UNITED STATES PATENT AND TRADEMARK OFFICE

APPLICATION NO.	FILING DATE	FIRST NAMED INVENTOR	ATTORNEY DOCKET NO.	CONFIRMATION NO.
10/547,688	02/23/2006	Kenny Chang	012350-0383686	7107

Office Action Summary	Application No. 10/547,688	Applicant(s) CHANG, KENNY	
	Examiner Andrew T. Piziali	Art Unit 1798

DETAILED ACTION

**FIG. 2**

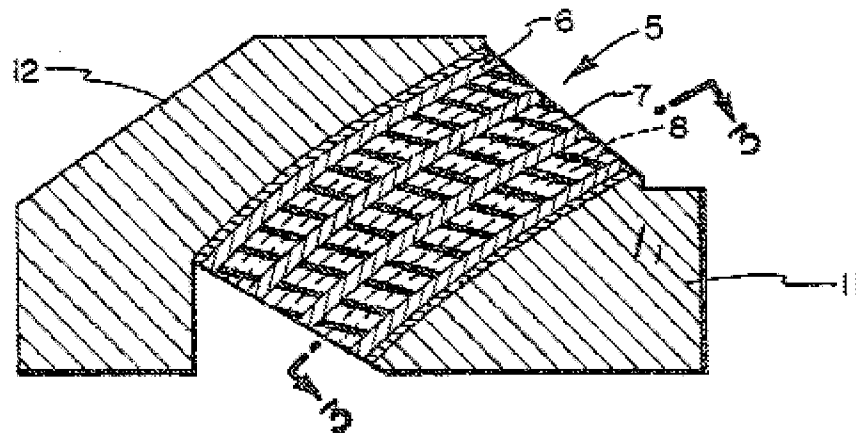
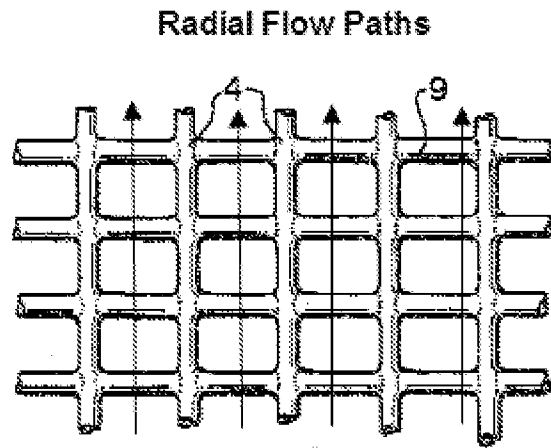
The applicant asserts that at the welded wire intersections there is no pathway for gas flow above or below the wires. Applicant's argument is not persuasive because that the feature upon which applicant relies is not recited in the rejected claims. The current claims simply require that the member at least partly defines a plurality of radially extending gas flow paths. Illustrated below is Figure 3 of Hickox which is a fragmentary section taken on line 3-3 of Figure 2 (column 2, lines 9-17). Arrows have been drawn to illustrate at least partly defined radially extending gas flow paths:

The woven knuckle intersections (4) protrude to provide channels that at least partly define radially extending flow paths (see arrows). It is noted that perpendicular flow paths (channels) also exist due to the woven knuckle intersections (4). The applicant is directed to page 7, lines 5-15 of the current specification wherein the claimed partly defined flow paths (channels) are discussed.
